Parts Manual

Series 90

55cc Axial Piston Pump

Service bulletin

Servo arm change

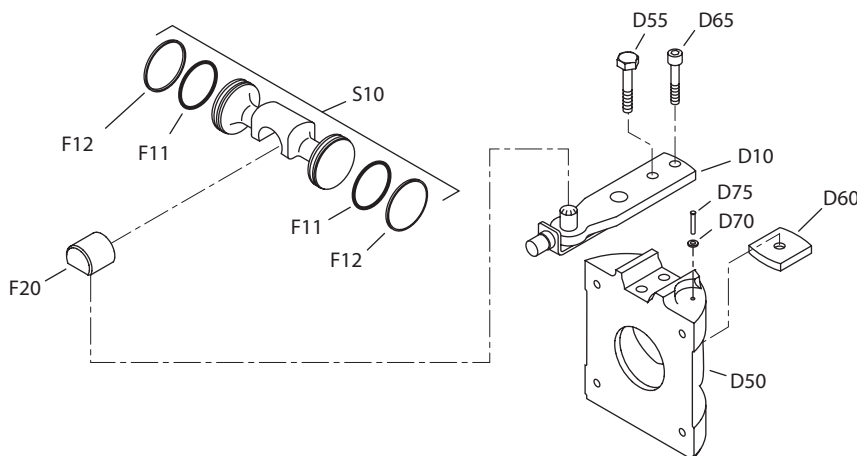
As a product improvement, Sauer-Danfoss has changed the series 90 pump servo arm and swashplate (item D10 and D50). The old style servo arm and swashplate will become obsolete. Because this change creates non-interchangeability between new and old swashplates, servo arms, and possibly servo piston (item S10) and slider block (item F20), separate servo arms and swashplates will no longer be sold as service parts.

Also, the new servo arm is actually a press fit into a groove in the new swashplate. This situation requires special tooling for assembly, therefore, pre-assembled kits will be created for 55, 75, and 100 cc pumps. The kits will work in any vintage pump.

The kit for 55 cc pumps will include all the items in the figure, except item S10

The kit for 75 cc pumps will include all item in the figure.

The kit for 100 cc pumps will include all items in the figure, except items S10 and F20.

Change goes into effect with s/n 88-14-xxxxx on 55 cc pumps and with s/n 88-16-xxxxx for 75 cc and 100 cc pumps.

Change to fixed clearance slipper hold down

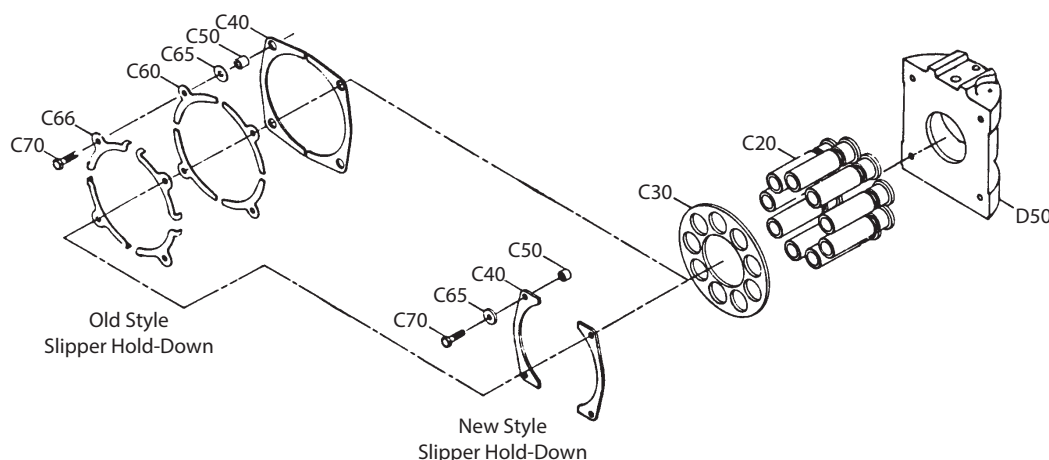
As a product improvement, Sauer-Danfoss has simplified the design of the series 90 pump slipper hold down mechanism. The hold down changes from spring loaded with a fixed maximum clearance design.

The leaf spring (item C60) and spring aligner (item C66) will be eliminated and will not be available as service parts.

The spacer (item C50), bearing (item C40), and washer (item C65) will change and the old part numbers will not be available as service parts.

Remote pressure filtration adapter change

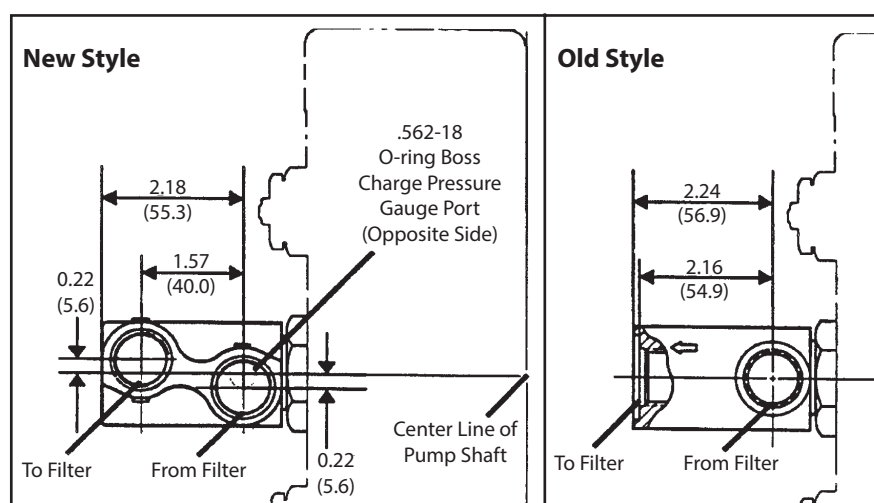
The configuration of the remote pressure filtration adapter, available as an option on Sauer-Danfoss series 90 variable pumps (55, 75, and 100 cc) is changing. This improved design adapter incorporates a charge pressure test port. In addition, the remote filter connections have been relocated to improve the customer interface and the routing for filter plumbing on most applications. Port sizes did not change. (A version of the improved design adapter is already being used on Series 90 42 cc variable pumps.)

This change does not affect the pump end cap, and either design filtration adapter can be used on any vintage pump. Only the new style adapter will be available as service parts or on new production pumps.

Swashplate leveler spring seat change and servo pressure relief valve deletion

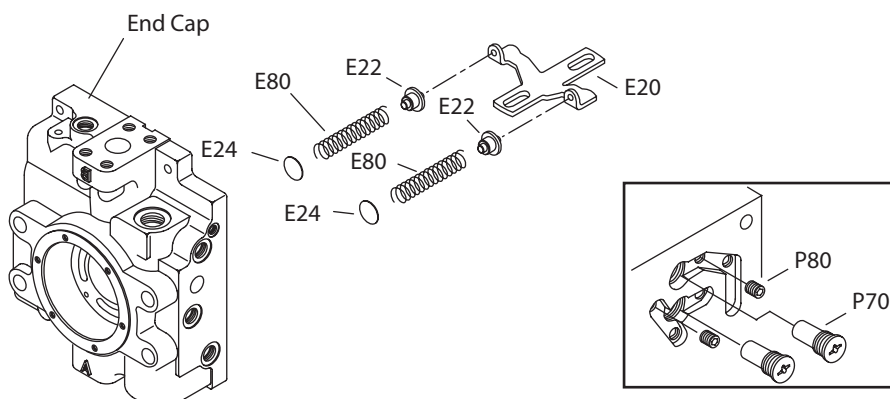
As a product improvement, Sauer-Danfoss is adding hardened shims between the swashplate leveler springs and the end cap in series 90 variable pumps. In addition, the leveler spring seats have been hardened, and are now separate pieces from the leveler. Previously, the seats were peened to the leveler.

In an unrelated change, the servo pressure check relief valves installed in the pump end cap (or rotation valve housing) are no longer required. These valves (P70) will be replaced by standard socket head, straight thread O-ring plugs.

The hardened swashplate leveler spring seats and hardened shims incorporated at serial number 89-09-xxxx. Due to the interchangeability of the straight thread plugs with the servo pressure check relief valves, this change will be incorporated during the 1st quarter of 1989.

Charge pump design change

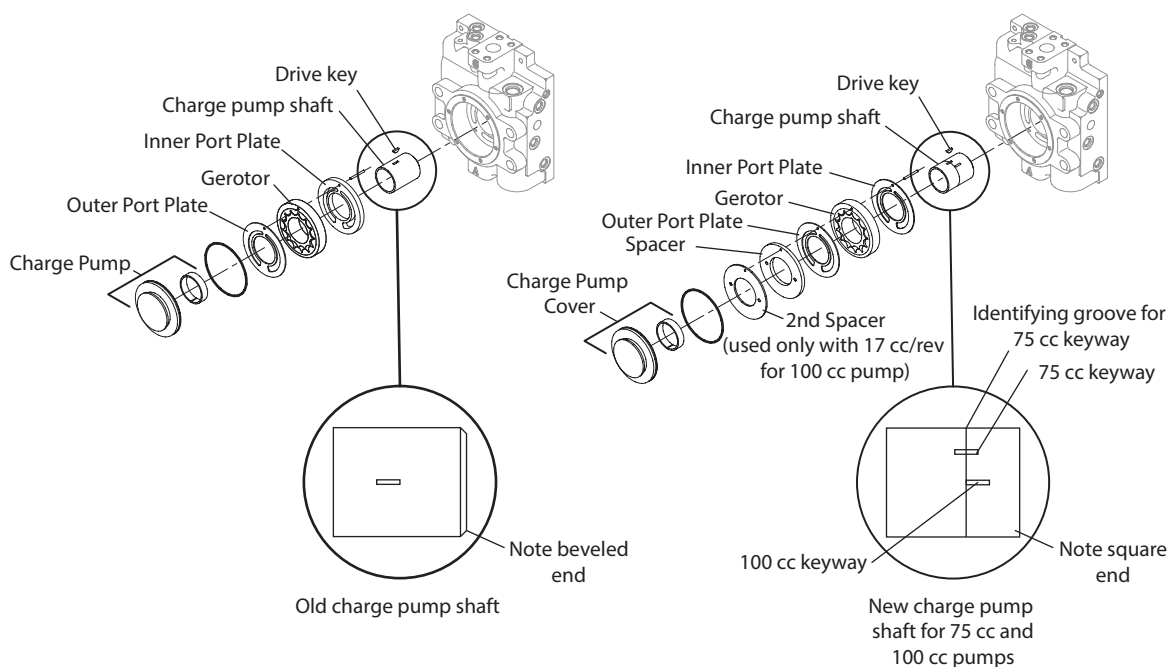
Models affected	All 94-2xxx (55 cc), 95-2xxx (75 cc), and 96-2xxx (100 cc) pumps
Serial numbers	A-89-17-xxxxx for all pumps manufactured in Ames, Iowa. N-89-07-xxxxx for al 95-2xxx (75 cc) pumps manufacture in Neumunster, West Germany. N-88-48-xxxxx for all 96-2xxx (100 cc) pumps manufacture in Neumunster, West Germany.
Part numbers affected	Proper part number versus pump serial number information can be found in the series 90 Parts Manuals. The thicker inside port plates (thicker than 0.050 in (1.27 mm) will be obsoleted and no longer available as service parts. If these parts require replacement, use the 0.050 in. 1.27 mm) port plate and appropriate spacer(s) as service parts. On 100 cc pumps only, the new charge pump shaft must be used if the new style spacer is used, On 55 and 75 cc pumps, the charge pump shaft clearance pocket in the end cap changed from a beveled to a straight corner to correspond with the change in the charge pump shaft. Old style charge pump shafts will remain available as service parts and must be used in the 55 and 75 cc beveled pocket end caps. Old style (beveled pocket) end caps will be obsoleted and no longer available as service parts. If an old style end cap needs replacement, new style end caps can be used with any vintage charge pump hardware and charge pump shaft.

Parts disposition	■ Non-interchangeable - must use correct charge pump shaft per serial number of pump

Change takes place at serial number A-89-17-xxxxx.

End cap and housing change

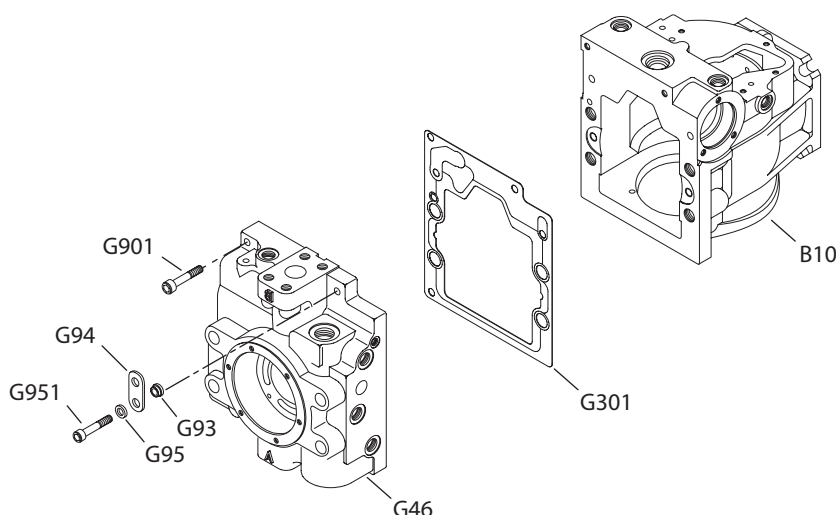
Change takes place at serial number A-89-47-xxxxx.

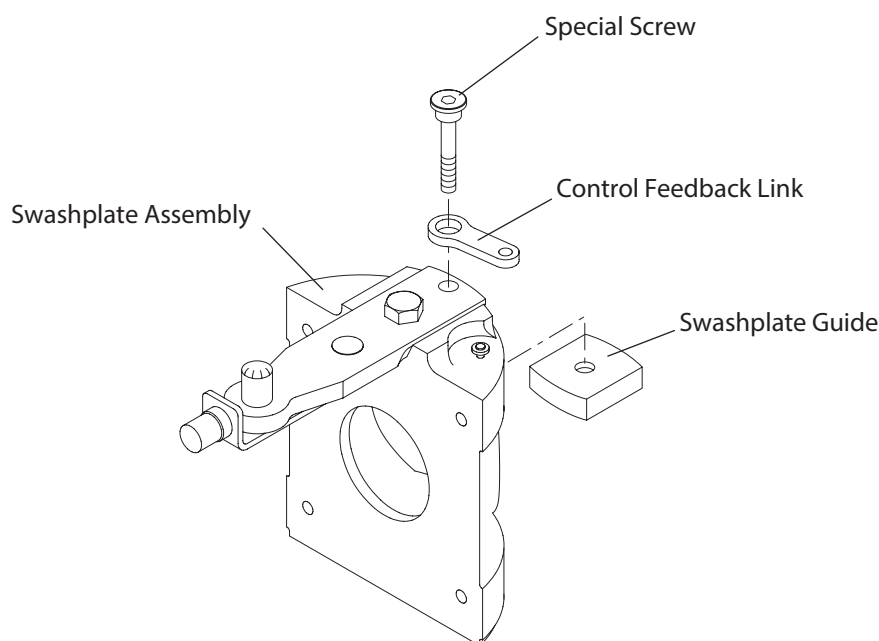
Effective in September of 1992, the feedback link in series 90 pumps will be mechanically retained to the swashplate. In the past, the link slipped over a specially ground socket head screw and could fall off the screw during assembly. The screw has changed to include a head to retain the link. The feedback link does not change.

Swashplate cage locator

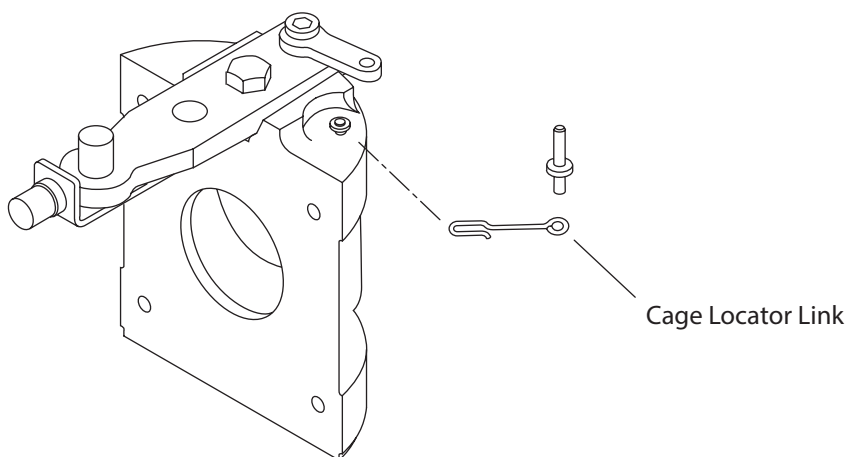
As a product improvement, Sauer-Danfoss has made a design change to the cage locator link used on the 55 thru 100 cc variable pumps.

The new link is made from square wire. In the past, the link was made from round wire. This is an interchangeable change.

Side cover washer elimination

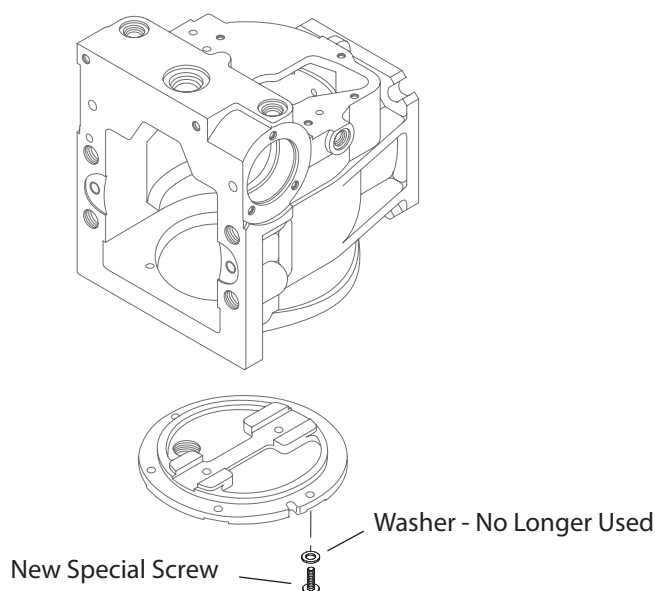
Change took place during the 2nd and 3rd quarter of 1994

Integral filtration manifold

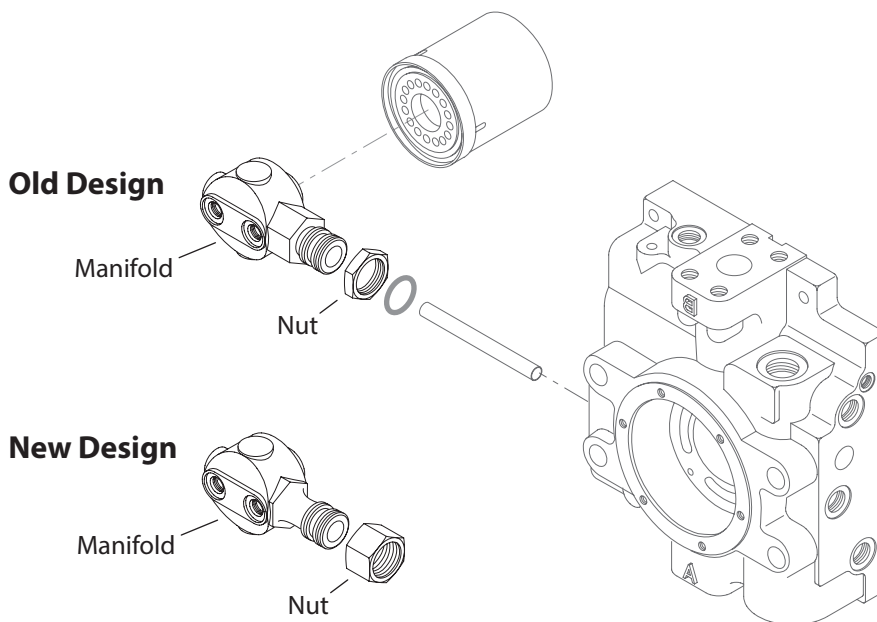
Change occurred at serial number 95-18-xxxxx

Subject Swashplate bearing cage locator pin

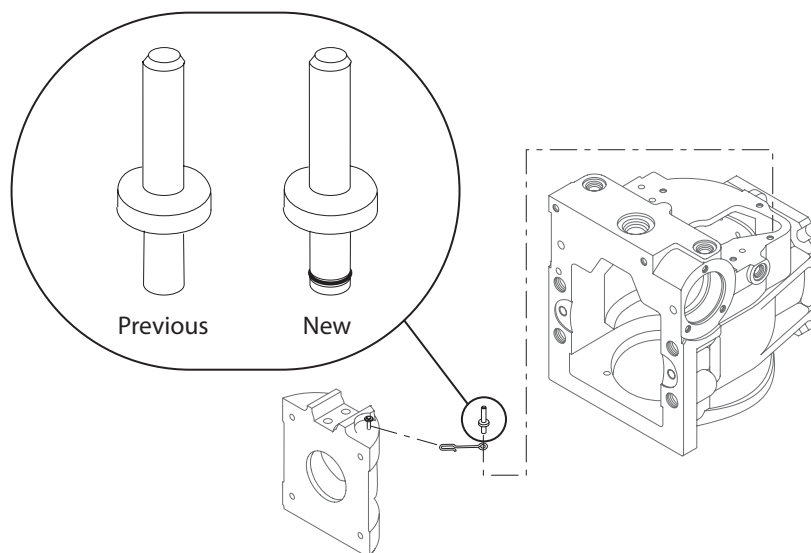
Description Sauer-Danfoss has modified the design of the swashplate bearing cage locator pin used in the series 90 55, 75, and 100 cc variable displacement pumps.

To aid in identifying this change, Sauer-Danfoss has released a new part number for the updated pin design. The new pin is completely interchangeable with the previous pin part number. The previous pin has been obsoleted.

Serial numbers This change became effective at serial number 98-24-xxxxx

Charge pump shaft part number change

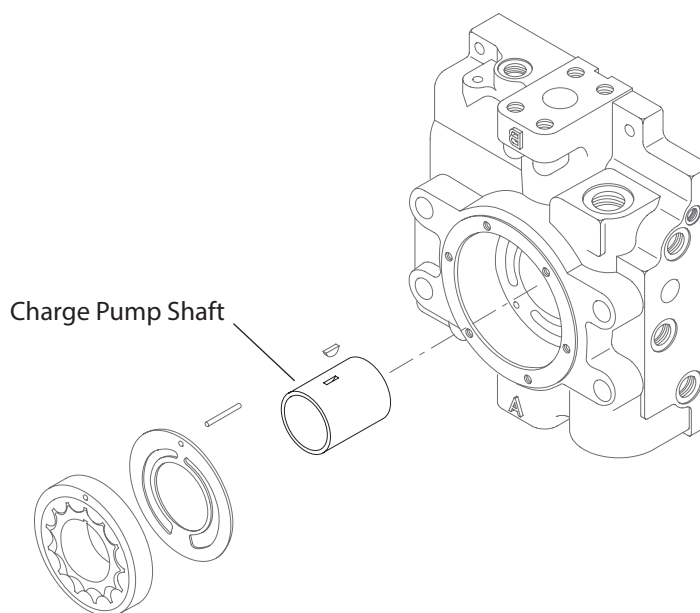
As a product improvement, Sauer-Danfoss has modified the design of the charge pump shaft used in series 90 55, 75 and 100 cc pumps. This change affects all charge pump sizes (11, 14, 17, 20, 26, and 31 cc) available in the series 90 displacement range.

The design modification includes a surface finish change to the charge pump shaft which improves the wear characteristics between the charge pump shaft and the journal bearings in the charge pump cover and end cap.

To assist in identifying this change, Sauer-Danfoss has released new charge pump shaft part numbers. The new shafts are completely interchangeable with the previous shafts. The new shaft has replaced the previous shaft in new pump assemblies and charge pump service kits. The previous shafts have been obsoleted and are no longer available as a service part. The chart on the next page will assist you in determining the part number changes.

Auxiliary flange charge pump cover

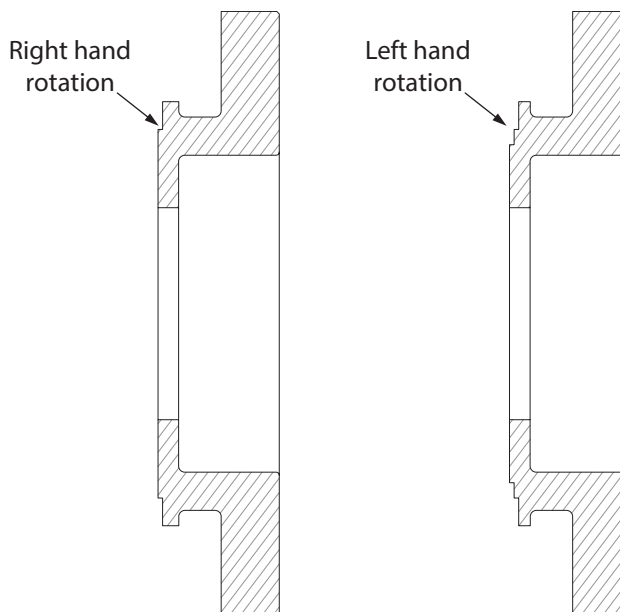
The part numbers of the charge pump covers will not change.

This change became effective at serial number A-05-17-xxxxx

Subject SAE C auxiliary mounting flange

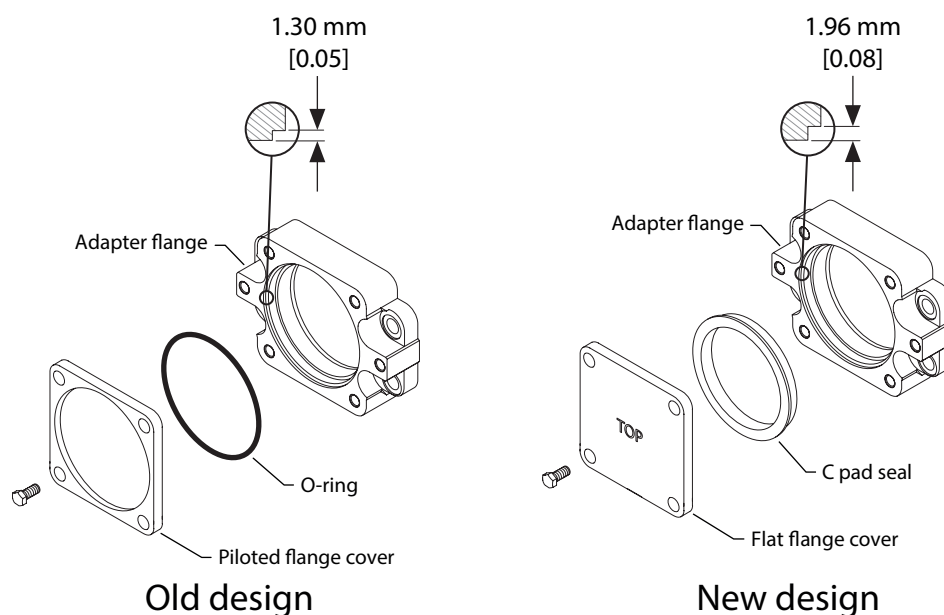
Part numbers affected Sauer-Danfoss is pleased to announce a design improvement on the SAE C auxiliary mounting flange adapter on its series 90 pumps. The frame sizes affected by this change are 55, 75, and 100cc. All manufacturing locations producing these pumps will be changed to this configuration.

The pumps will now be supplied with the donut style seal and new flat cover, instead of the small O-ring and cover plate (shown in the drawing below).

Serial numbers This change became affective at serial number; A 08-19-xxxxx and N 09-30-xxxxx.

Subject SAE B auxiliary mounting flange

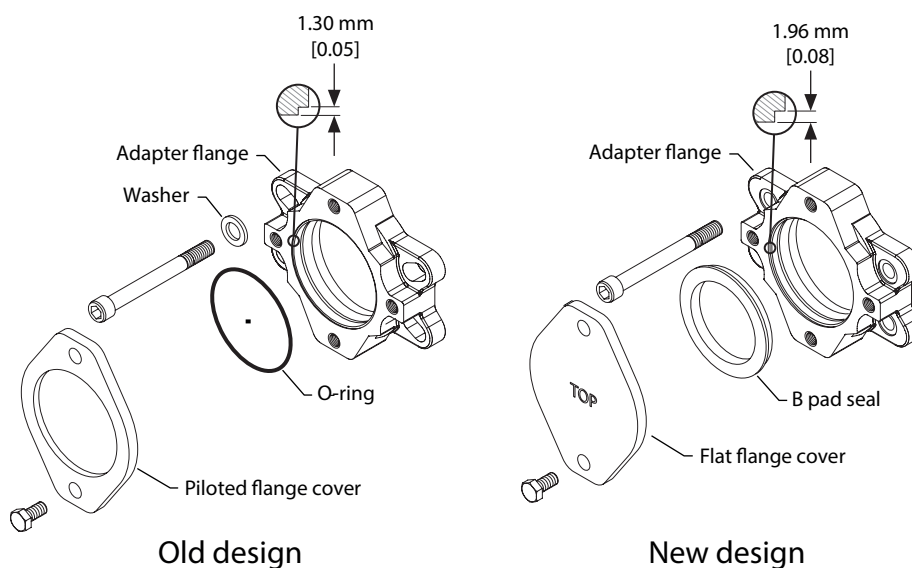
Part numbers affected Sauer-Danfoss is pleased to announce a design improvement on the SAE B auxiliary mounting flange adapter on its series 90 pumps. The frame sizes affected by this change are 55, 75, and 100cc. All manufacturing locations producing these pumps will be changed to this configuration.

The improvement comes in the form of a more robust sealing geometry with a larger cross-section O-ring. The O-ring groove in the flange will now be sized to mate with a 2.62mm [0.103] cross section O-ring rather than the old 1.78mm [0.070] cross-section O-ring. The Sauer-Danfoss part number for the new O-ring is 9004104-1540 (2.62mm [0.103] x 94.92mm [3.737]). The larger cross-section sealing geometry allows for the use of a donut style B pad seal and a new flat cover for improved assembly. This new configuration is qualified as a running cover. When installing an auxiliary pump, the donut style B pad seal must be discarded and part number 9004104-1540 O-ring used.

Also, the flanges will no longer have a slotted interface with a washer for the end cap screws. The flanges will now have round through holes for the end cap screws and will use no washers. The end cap screws do not change. This eliminates the area where water or high pressure wash chemicals can be trapped around the end cap screws. There now are specific part numbers for the flanges used on each of the three displacement size pumps; 55, 75 and 100 cc.

The pumps will now be supplied with the donut style seal and new flat cover, instead of the small O-ring and cover plate (shown in the drawing below).

Serial numbers This change became affective at serial number; A 08-19-xxxxx.
